Informal document **GRE-78-10-Rev.1**
(78th GRE, 24-27 October 2017,
agenda item 7 (a))

**Task Force
on Electro-Magnetic Compatibility
(TF EMC)**

Status report to GRE-78
Wednesday, 25. October 2017

TF EMC Status Report

Spanish Proposal regarding DC charging mode

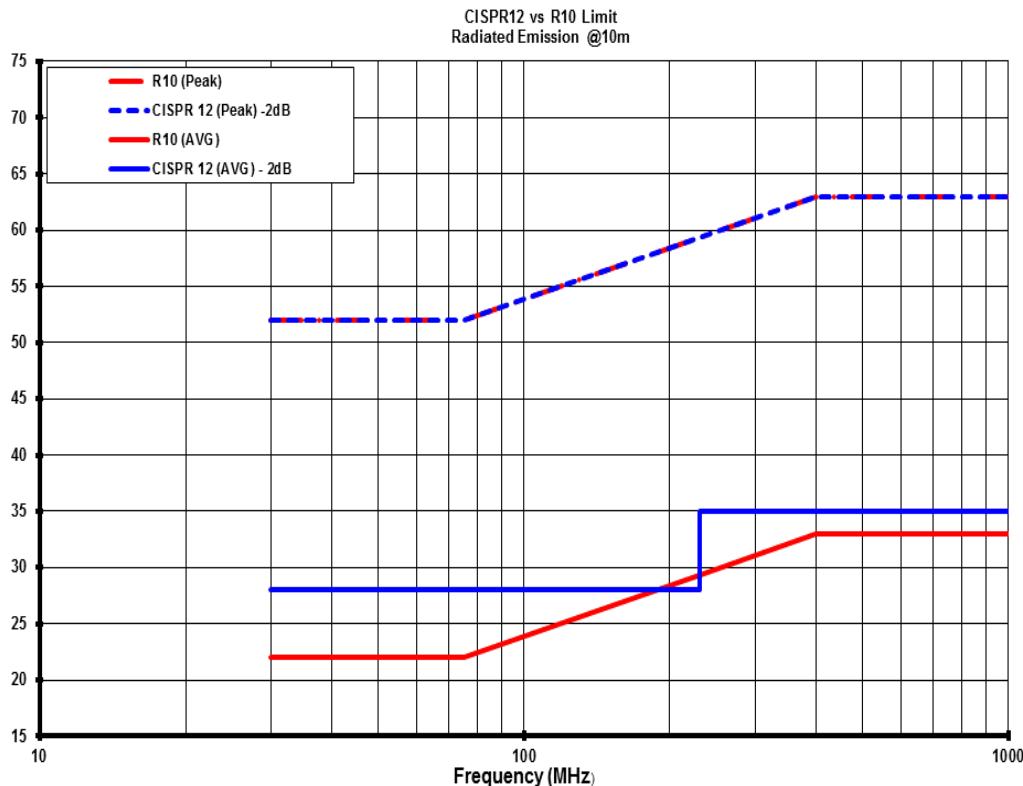
- The needs for charging of heavy vehicles as trucks or busses in short time leads to high charging current
- In the present version of UN R10.05 a test procedure is defined to test at a current level of 80% .
- Laboratories are in trouble to fulfil the resulting requirements regarding the energy supply and test equipment. They also have to invest in continuously new equipment with increasing demands.
- For the time being, the test requirements can not be fulfilled by most of the laboratories. So for each test, the technical service has to consult the national regulation authorities.
- Therefore the TF EMC will prepare a proposal and a justification for an adoption of the test setup and requirements.
